# UNITED STATES PATENT AND TRADEMARK OFFICE

APPLICATION NO.	FILING DATE	FIRST NAMED INVENTOR	ATTORNEY DOCKET NO.	CONFIRMATION NO.
10/766,671	01/28/2004	Dorian Thurston True	42576/282562	3032
23370	7590	06/27/2007		
JOHN S. PRATT, ESQ KILPATRICK STOCKTON, LLP 1100 PEACHTREE STREET ATLANTA, GA 30309			EXAMINER HAWK, NOAH CHANDLER	
			ART UNIT 3636	PAPER NUMBER
			MAIL DATE 06/27/2007	DELIVERY MODE PAPER

## Office Action Summary

## DETAILED ACTION

Peta, Figure 2

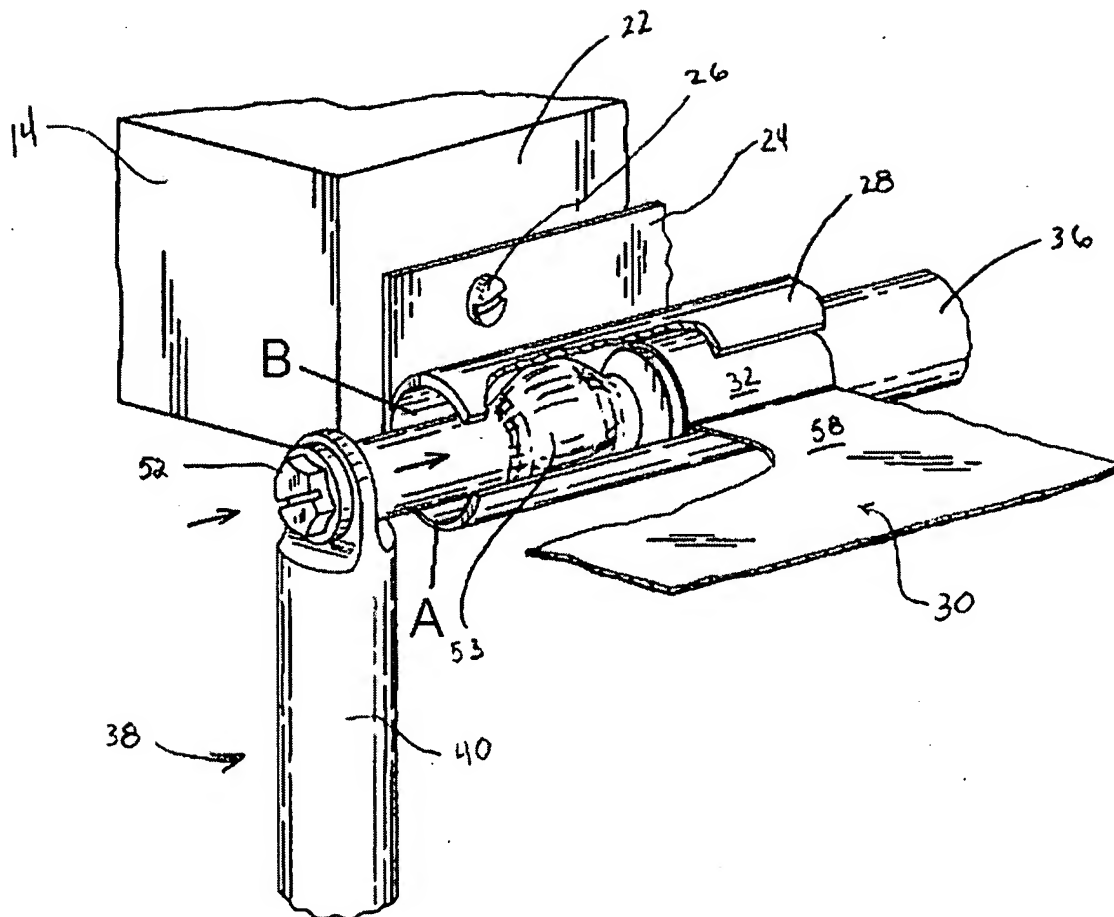
a. Regarding Claim 1, Peta teaches an apparatus for covering the rear of a golf cart, the apparatus comprising a stationary frame member (comprising at least 40, 42 and A), a movable frame member (56), and a cover (58), the stationary frame member mounted on the golf cart by brackets (24).

- b. Regarding Claim 3, Peta teaches that the stationary frame member comprises a U-shaped frame having a horizontal portion (A) and two legs (40, 42).
- c. Regarding Claim 4, Peta teaches that the horizontal portion (A) of the frame member is mounted to the brackets (24).

- d. Regarding Claim 5, Peta teaches that the movable frame member comprises a U-shaped frame with a horizontal portion (66) and two legs (70, 72).
- e. Regarding Claim 6, Peta teaches that at least one leg (70) of the movable member mounts to a respective leg (40) of the stationary frame member.

- f. Regarding Claim 7, Peta teaches a retainer bar strip (28) including a channel (B) and a retainer bar (36) wherein a portion of the cover (32) fits within the channel when the retainer bar is positioned within the channel.

- h. Regarding Claim 9, Peta teaches a strap (76) configured to restrain the cover adjacent the stationary frame member.
- i. Regarding Claim 11, Peta teaches an apparatus for mounting to a golf cart, the apparatus comprising brackets (24) configured to be attached to the support frame and the roof (22), a stationary frame comprising a U-shape frame with a pair of arm tubes (40, 42), and a connecting tube (A) mounted to the rear support frame of the cart, a movable frame comprising a U-shape piece with two arm bars (70, 72), with at least one connected to the stationary frame (Best seen in Figure 3), and a connecting bar (66), the movable frame rotatable over a portion of the rear compartment of the golf cart, a cover retainer strip connected to the stationary frame comprising an elongate strip (28), a channel recess (B),

and a cover (58) connected to the retainer strip extending from the channel recess and over the movable frame (Best seen in Figure 1).
